**KAWARTHA PINE RIDGE DISTRICT SCHOOL BOARD
PUR24-087-ITT
Clarke High School Classroom Refresh**

ADDENDUM NO. 2

Project No.: 24035
Date: May 9, 2024
Tender No.: PUR24087-ITT
Project: **RECONFIGURATION CLASSROOMS AT CLARKE HIGH SCHOOL**
Kawartha Pine Ridge District School Board

5 RM 203
A701 1:50

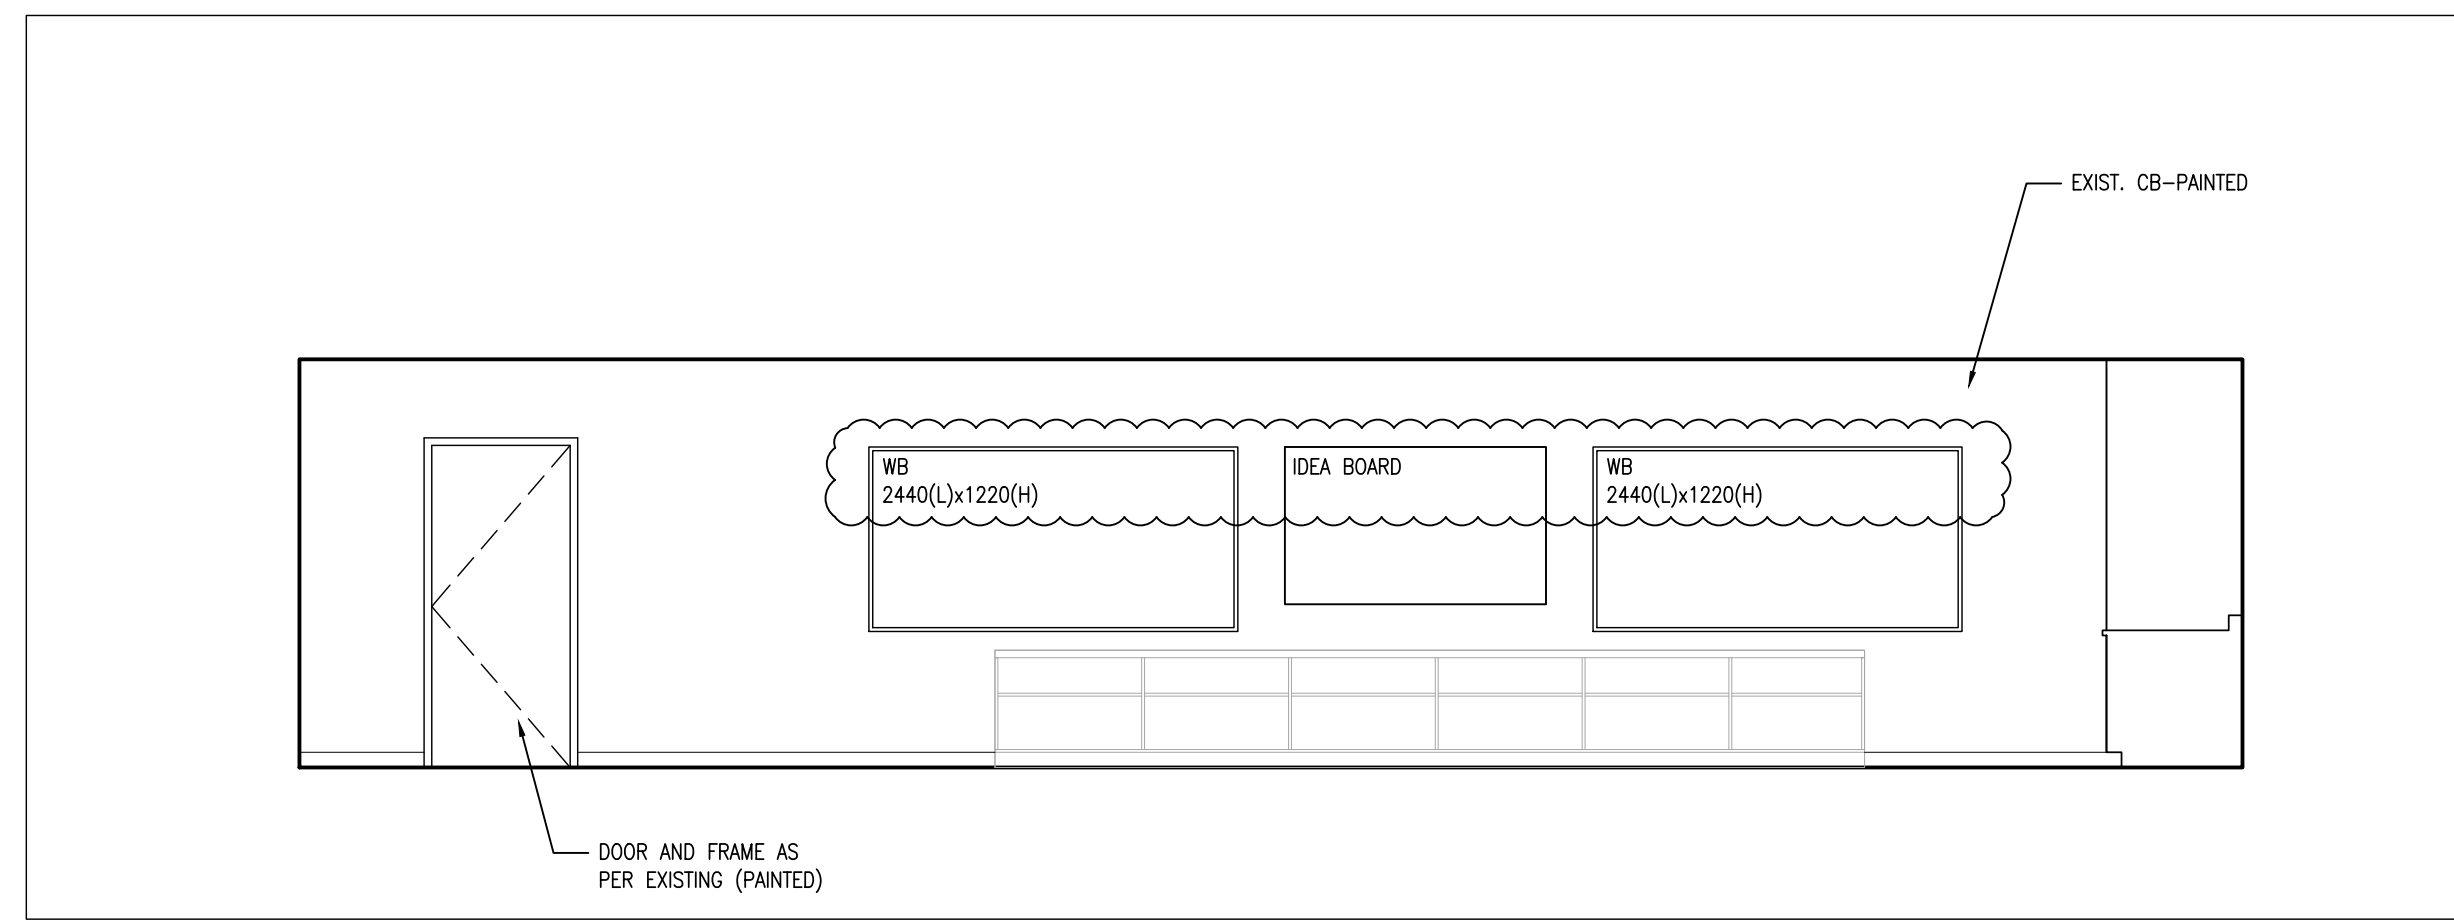
1.6 DRAWING SHEET A701 INTERIOR ELEVATIONS AND SCHEDULES

- .1 Revised door schedule: Fire resistant glazing "FRG" for Door 101.
- .2 Revised detail 5/A701.

PROJECT NO: **24035**
DRAWING NO: **A801**

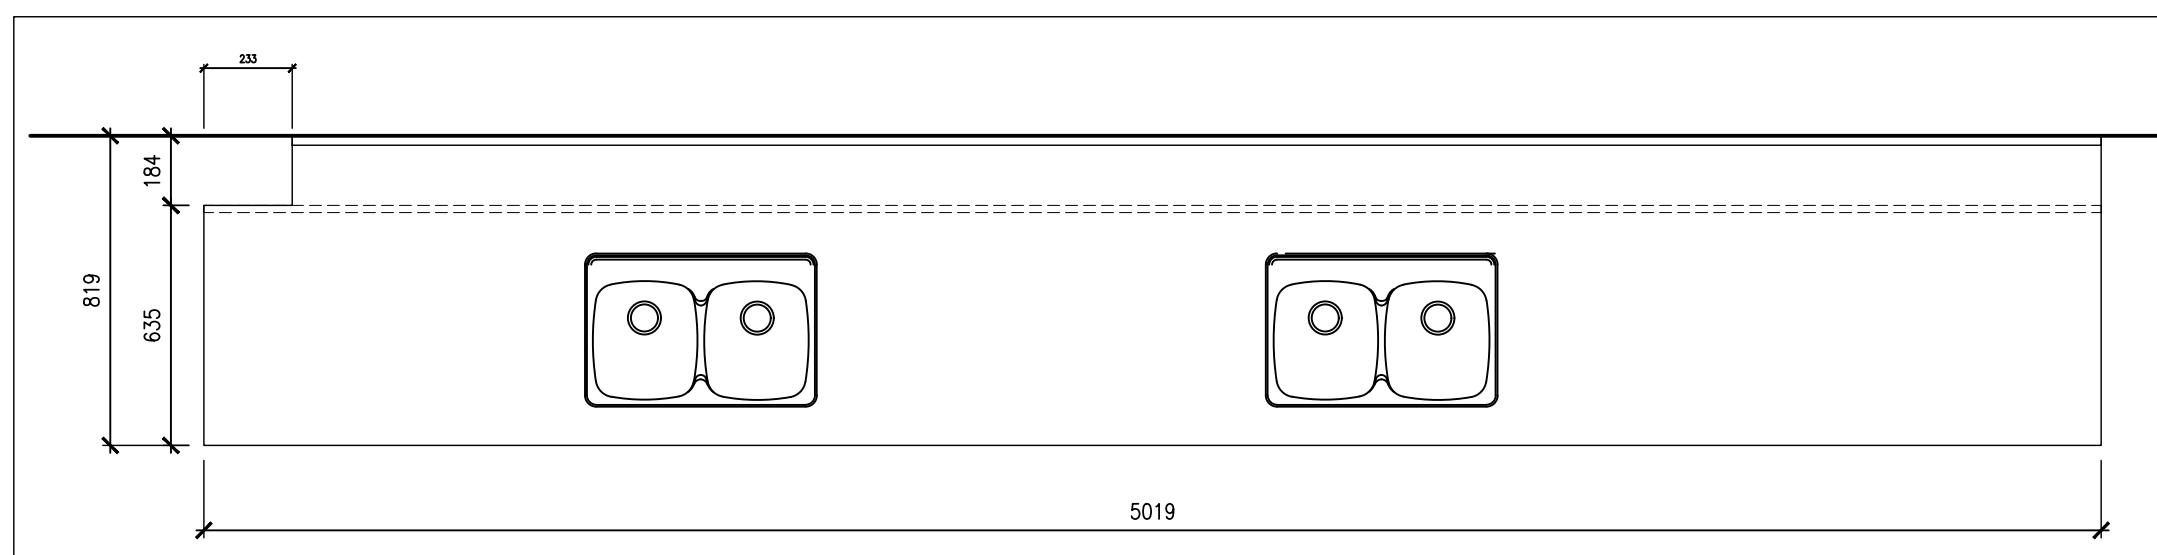
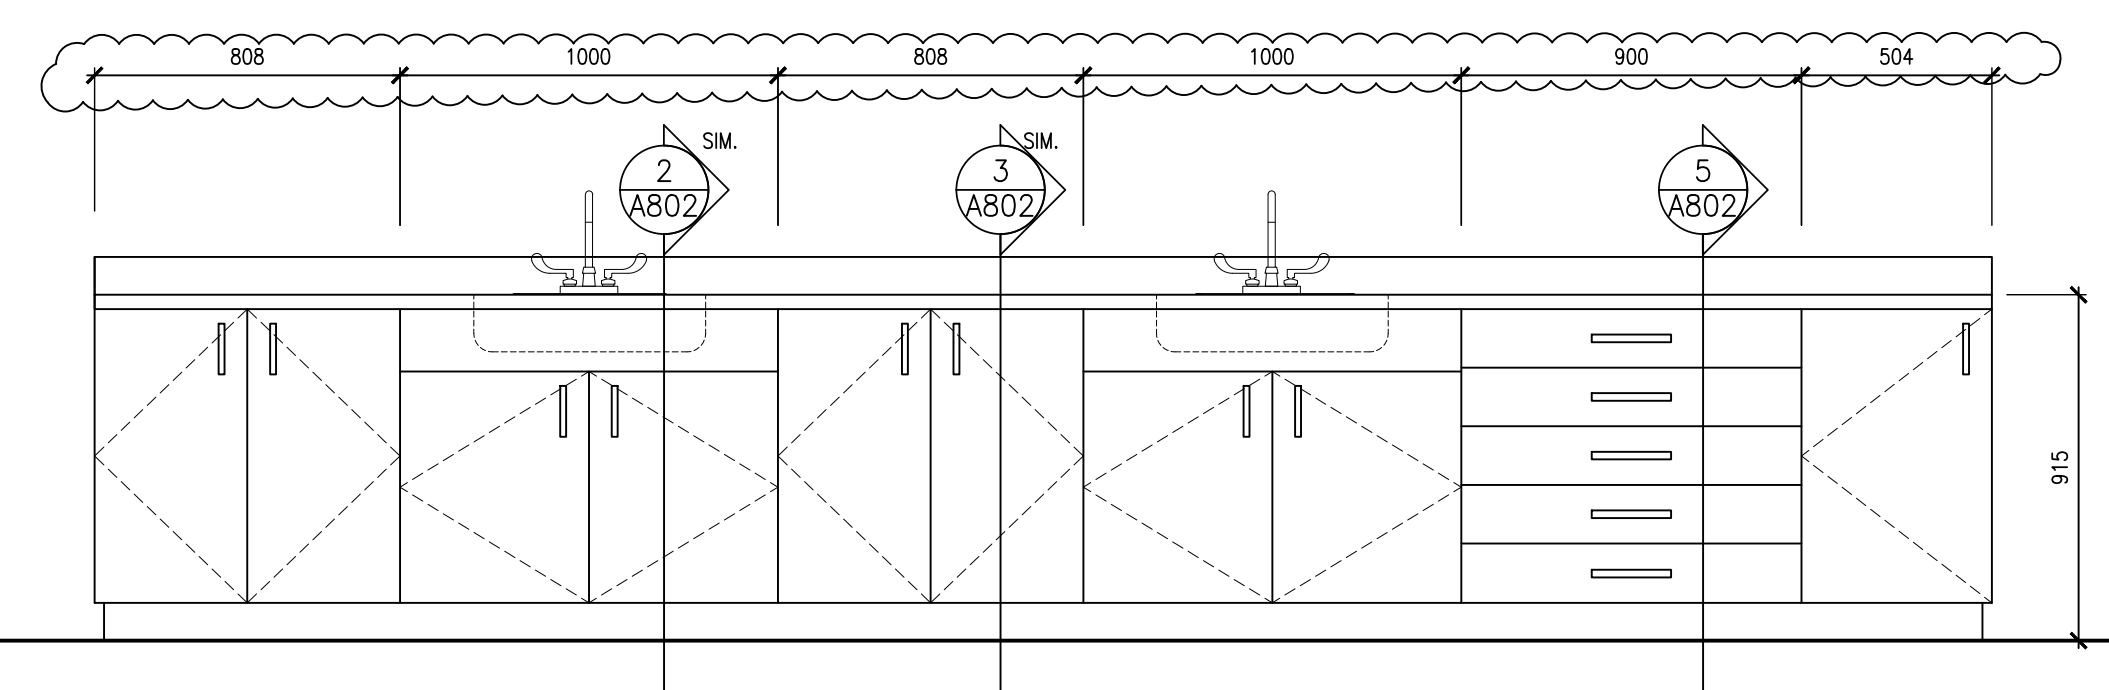
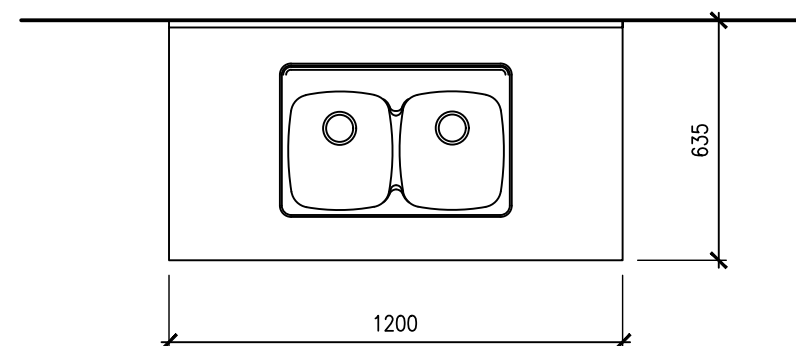
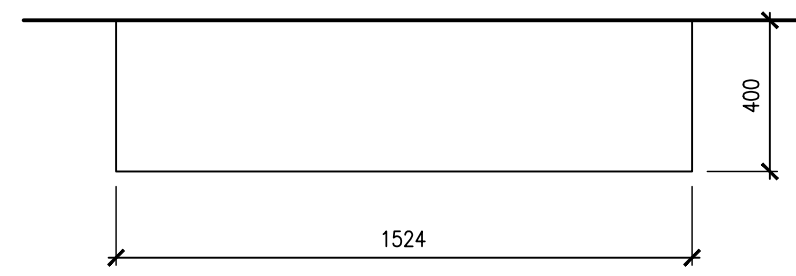
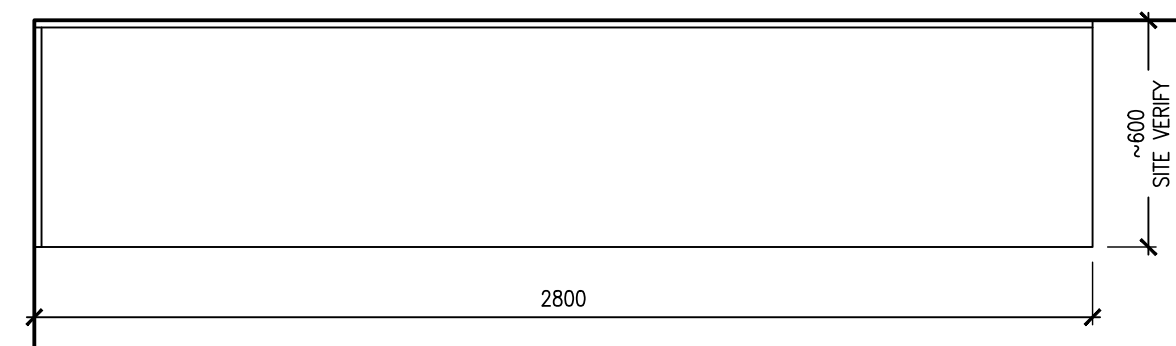
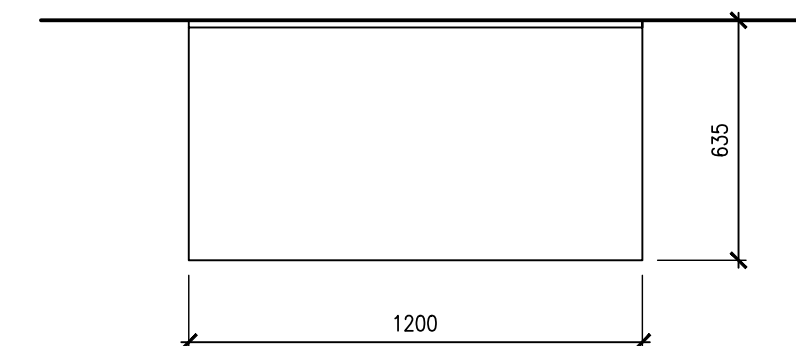
1.7 DRAWING SHEET A801 MILLWORK DETAILS

- .1 Additional dimensions.
